RE: Wayne County Board of Education
FHS-CTE (Dollar General Building) Renovation
TFM# 03387-C Project #2023-07-03-01
506 Main Street
Clifton, TN 38425

Bid Addendum #1

DOOR & WINDOW TYPES

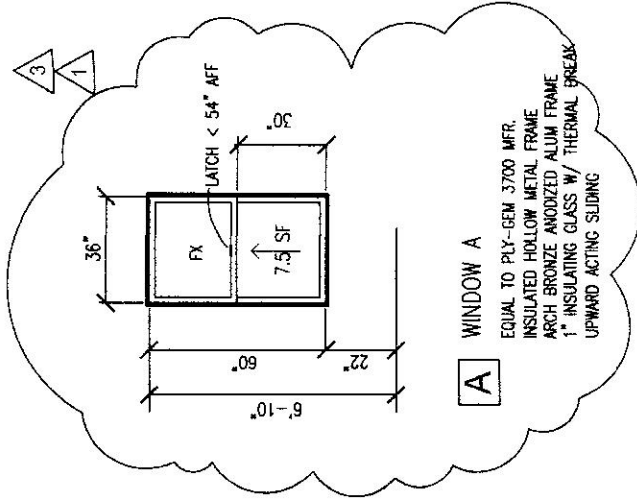
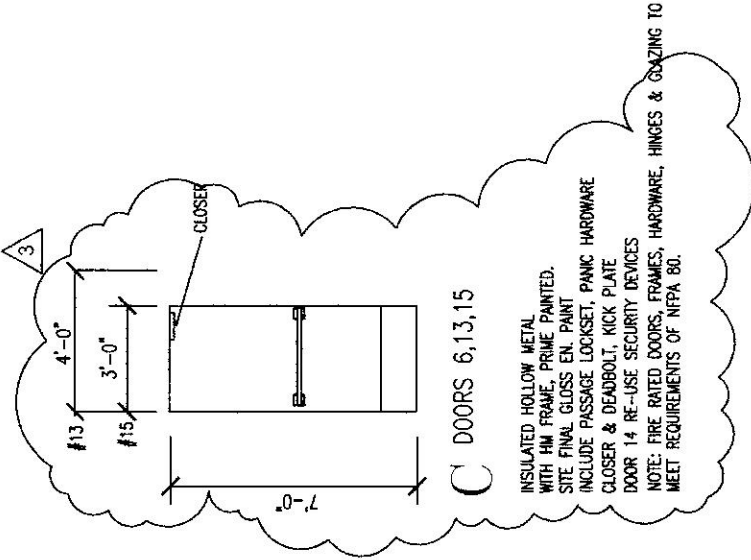
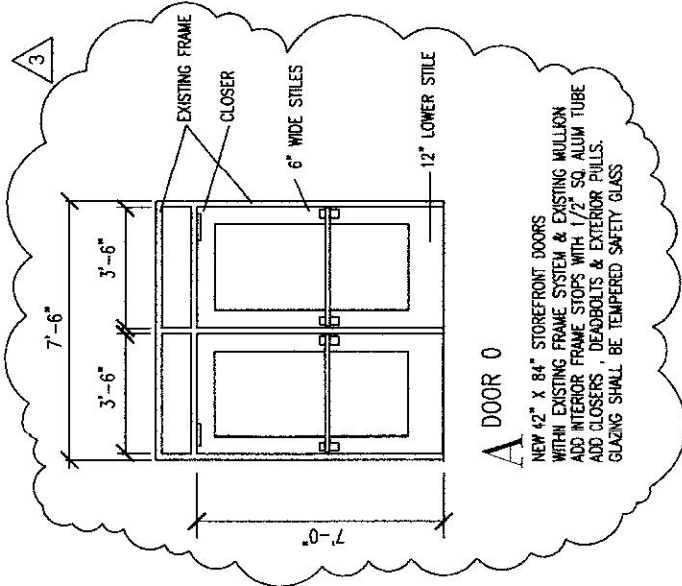
Item 5. Please see attached partial Sheet A1.1: Door #6,13 & 15 are Type C. Due to recent damage of the existing storefront door please include in the bid two new 42" wide doors and specified hardware as described under Door 0 in Door Type A, new aluminum storefront doors to fit within the existing frame system.

Item 6. Please see attached partial Sheet A1.1: Window "A" design standard or equal to be similar to manufacturer Ply-Gem series 3700 with associated opening, glazing and frame specifications.
